## BUILDING PERMIT

Permit Number: 090538

This is to certify that 63 KELLOGG STREET, LLC Construction Robert Nielsen  
has permission to Rebuild 1st floor rear, add 2nd floor sun room & rebuild 2nd floor deck & add 3rd floor deck  
AT 63 KELLOGG ST City of Portland 017 A003001

**City of Portland, Maine - Building or Use Permit Application**

Site Plan

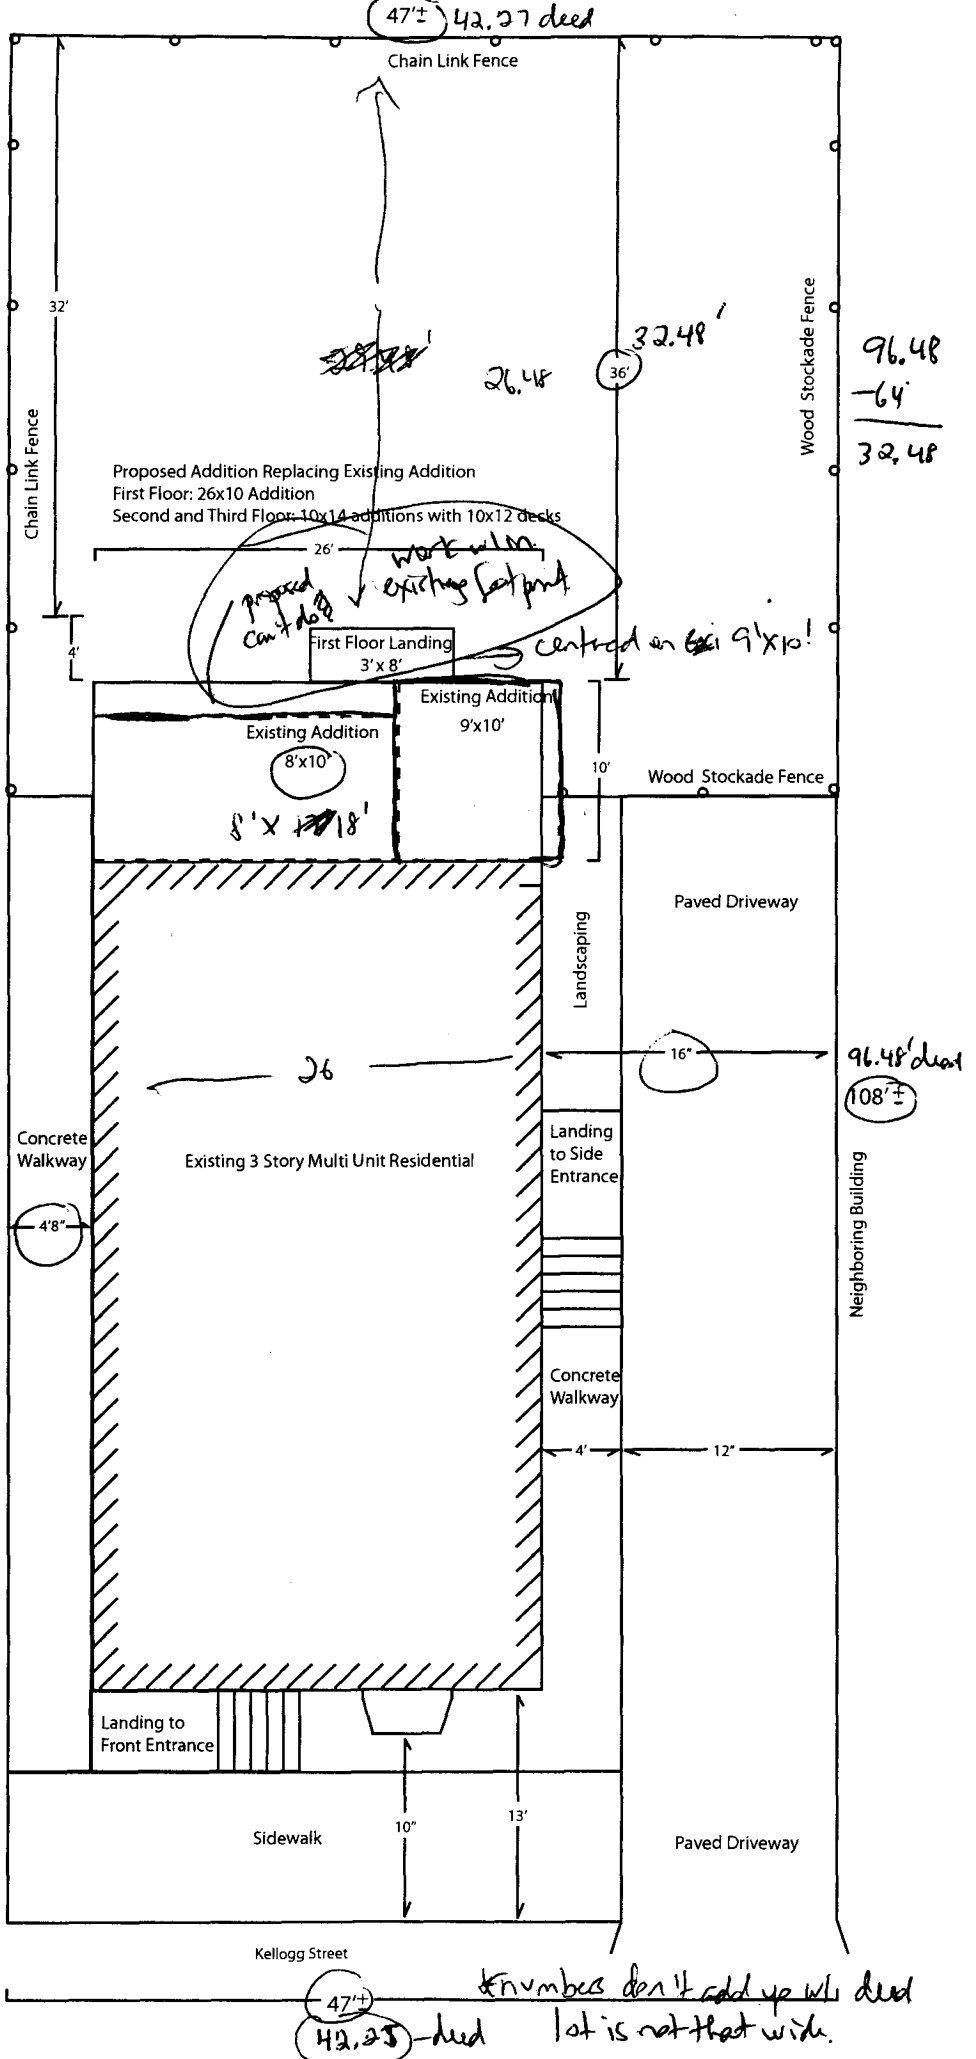
\* side - 10' - not need it on the left

Section 14-436(b)

\* doesn't meet 14-433  
- doesn't have 5' inside.

63 Kellogg Street  
 FIRST FLOOR - Renovated Floor Plan  
 1/8" = 1' All Sizes Approximate. Revision Date: 6/5/09

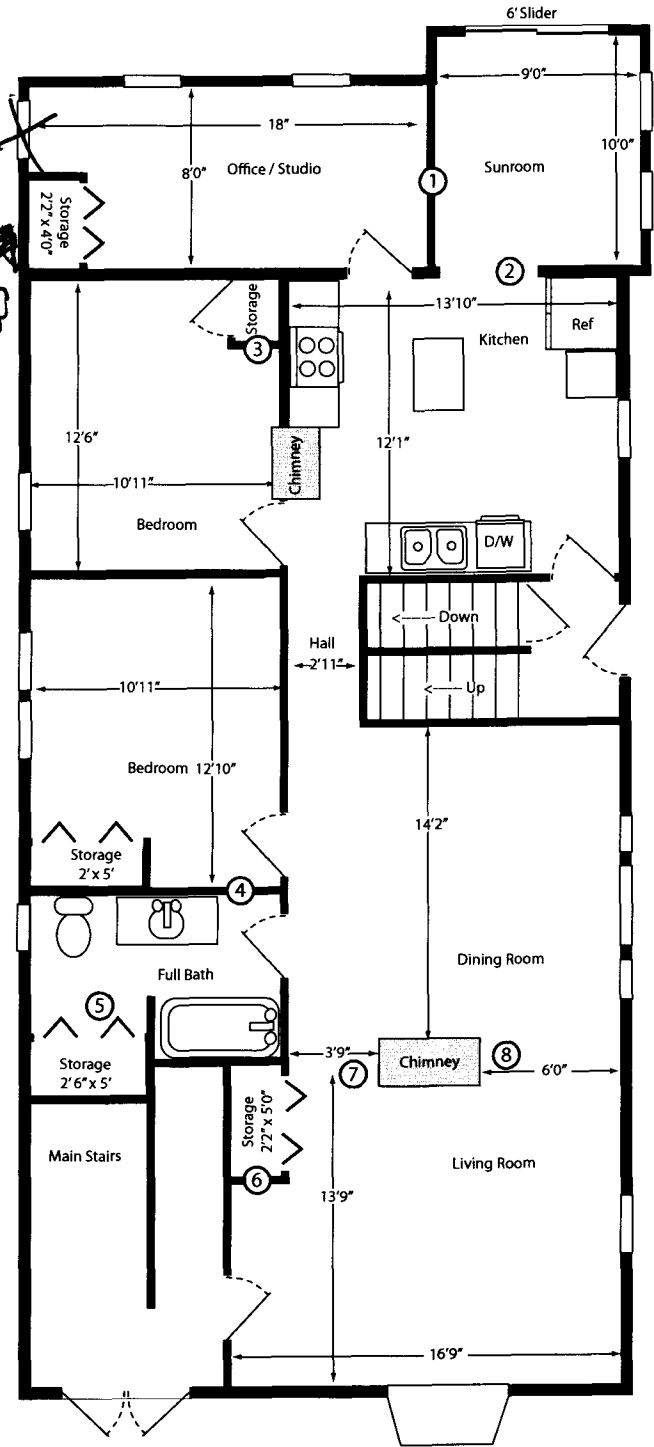
Window not allowed  
 Packed wall  
 5' both sides

Revised to conform to existing footprint

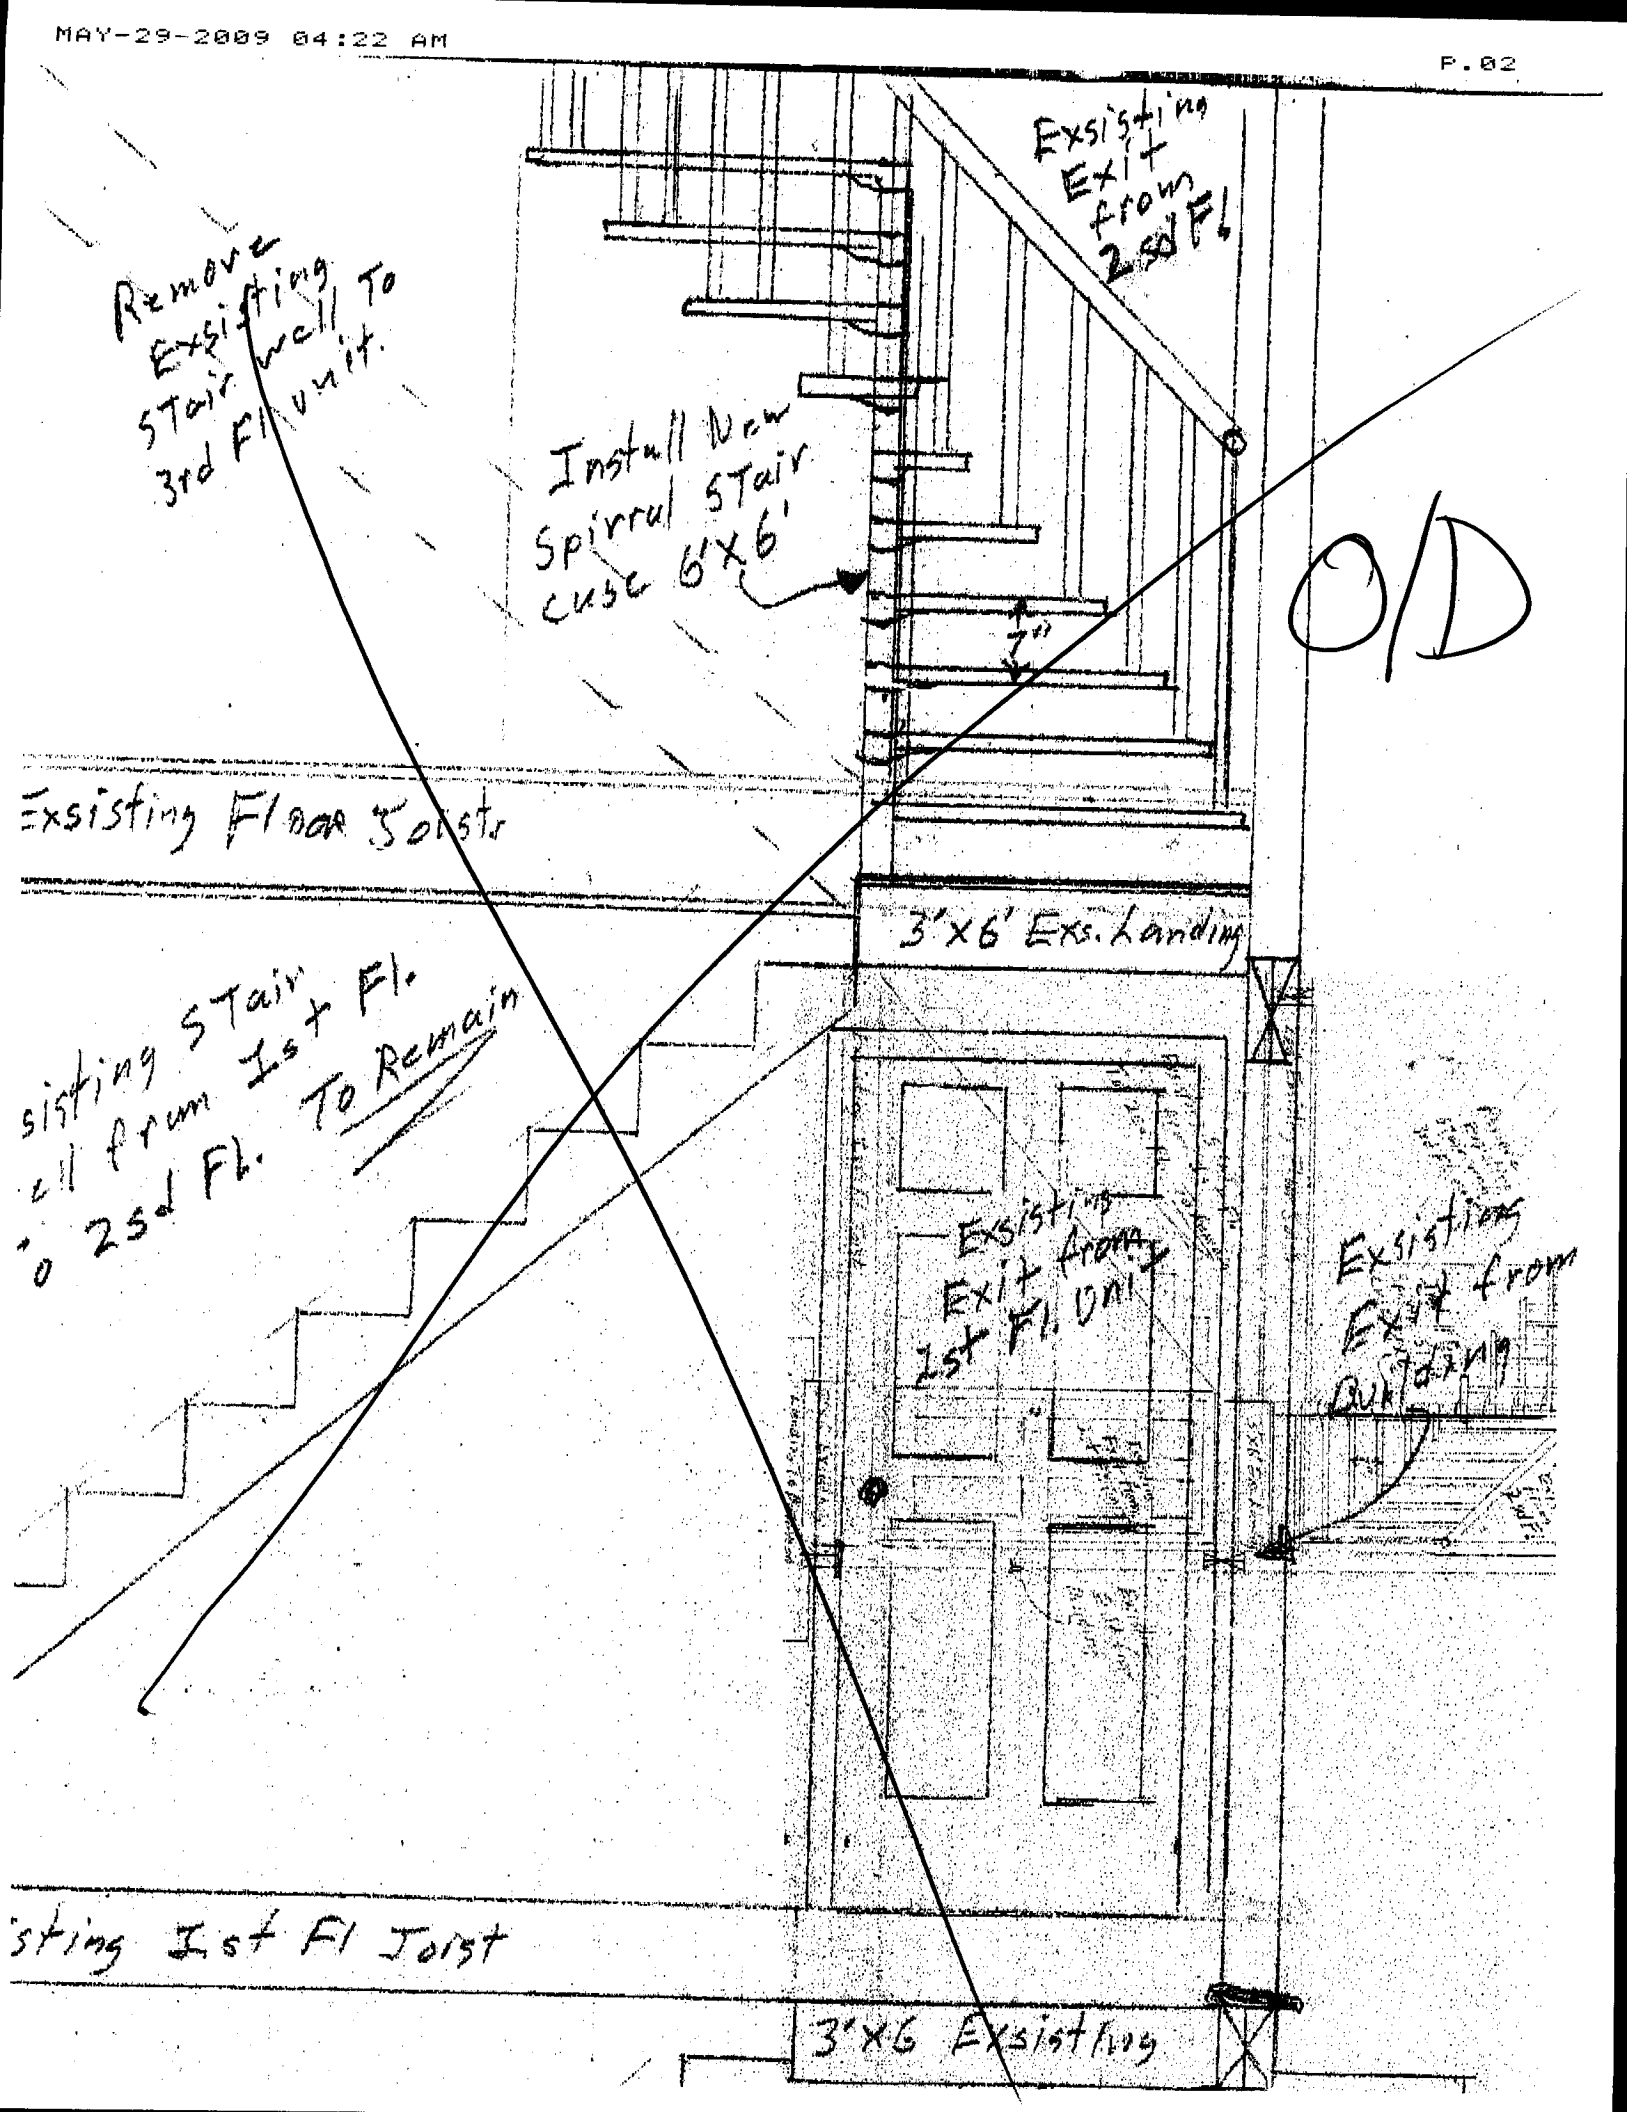
6/22/2009-jmb: Spoke with Dominic W. About details of the review and required submissions, some issues are a spiral stairway being used for a common egress, fire/sound separation, framing, egress window, smoke detector and recessed fixture details. He will submit or have the contractor call.

63 Kellogg Street  
 FIRST FLOOR - Renovated Floor Plan  
 1/8" = 1' All Sizes Approximate. Revision Date: 6/26/09

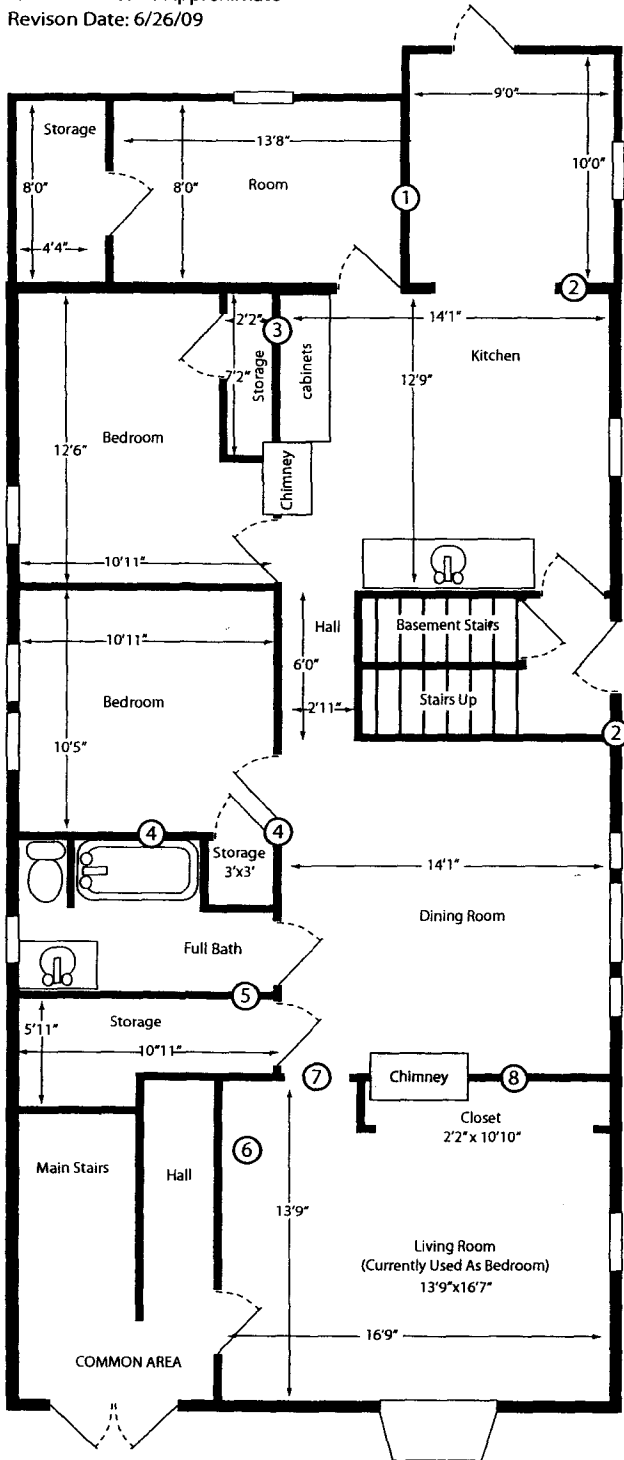
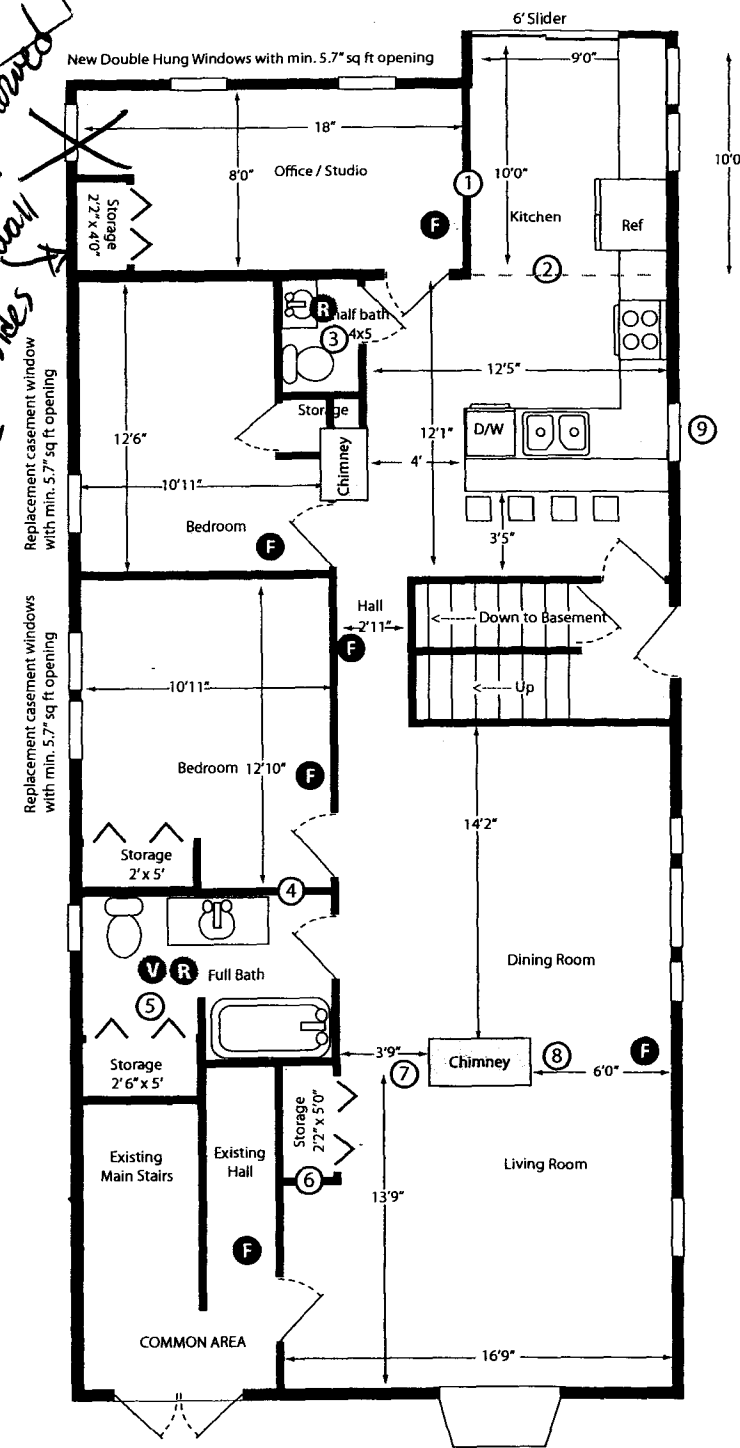
7/8/2009-jmb: Received fax from Anderson Insulation, shows factor for a 2x4 wall to be STC 37. Therefore, floors at 2x10 foam packed will meet the code. Note: realized that the new left side wall is less than 5' from the property line. This wall is required to be 1hr. Rated with exposure from both sides Sec.704.5 and no openings allowed. Dominic will have the contractor provide a detail.

7/9/2009-jmb: Dominic & contractor submitted spec on 1/2" fire retardant plywood for 30minute rating. I marked up plans to show that wall to be 1hr rated with no openings. Ok to issue

*Windows not allowed  
 < 5' from PL  
 fire wall  
 1 in total - both sides*
